PROPOSED SUB DIVISION LAY-OUT APPROVAL FOR M/S. BAISHNODEVI ENGINEERS & CONSULTANCY PVT. LTD. SRI BIRANCHI NARAYAN MISHRA (M.D.) OVER PLOT NO-625 & 626, KHATA NO.- 469/1035 & 469/1935, MOUZA - PANCHAGAON, BHUBANESWAR, DIST-KHORDHA.

Ref:-Clarifications to queries as regards Plot No-625, Khata No-469/1035 and Plot No-626, Khata No-469/1935 in Mouza-Panchagaon as inquired on dt. 28.08.2023.

2562
No. BP/BDA, Bhubaneswar, the
LPBA(157/2020)

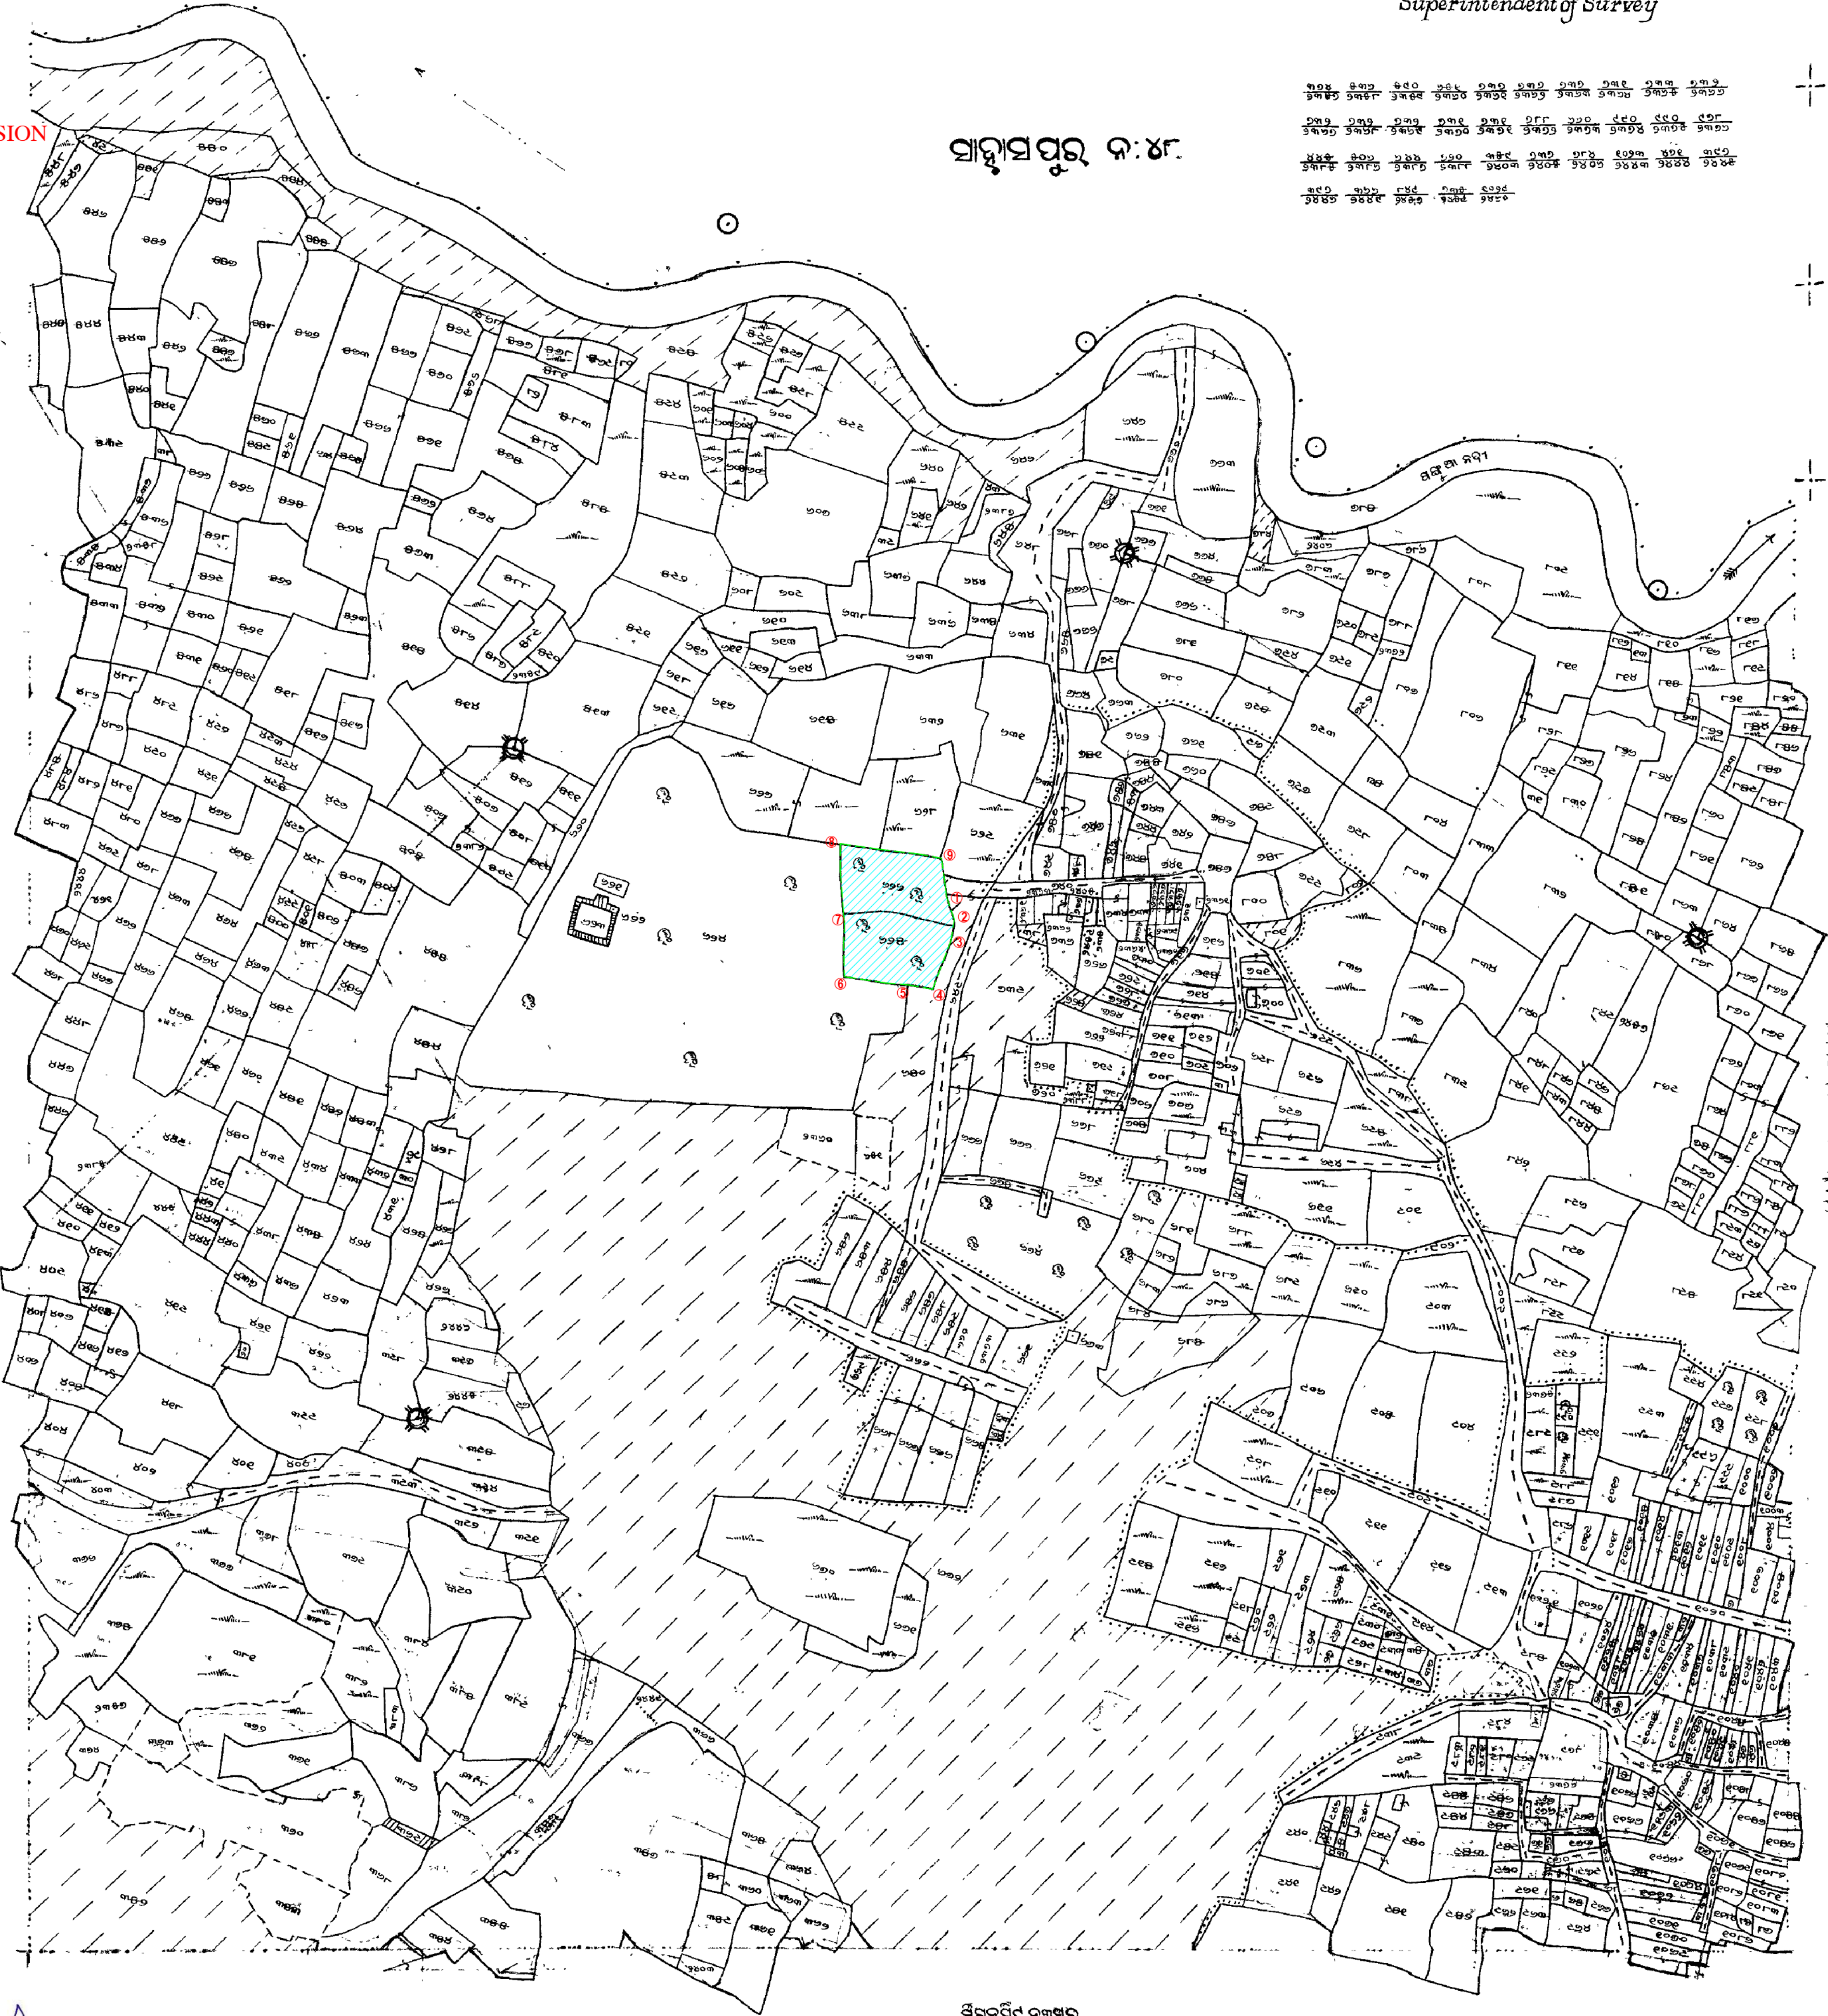
Point No-3:- I have to clarify that earlier, BDA had inquired in respect of the connecting road to Plot No-625 & 626 in Mouza-Panchagaon, by item no-23 of its letter vide Letter No-BP/BDA,Bhubaneswar-2562 (LPBA 157/2020) on dtd-19th January, 2021 and after duly inquired by the Tahasildar, Jatni has issued the clearance letter in respect of the connecting road to revenue Plot No-626 vide its Letter No-3903 dtd-24.06.2021. Further, after receipt of the said clearance letter by the Tahasildar, Jatni, it was placed before the BDA 241st DP & BP committee meeting for approval of sub-divisional land (Layout) of our project "SAI SUBAS" over revenue Plot No-625 & 626. Accordingly, BDA DP & BP committee has approved our land (layout) proposal.

23. Pl. submit an NAC obtain from Tahasildar to use plot no- 650
24. as approach road to the project submitted for sub-division
25. of land layout.

Further, it is to be stated that a portion of plot no-650 used as public road which is connecting to our project is correct as per the BDA DP & BP committee and Tahasildar, Jatni report vide its Letter No-3903, dtd-24.06.2021 along with RI report and the sketch map. (All the documents attached)
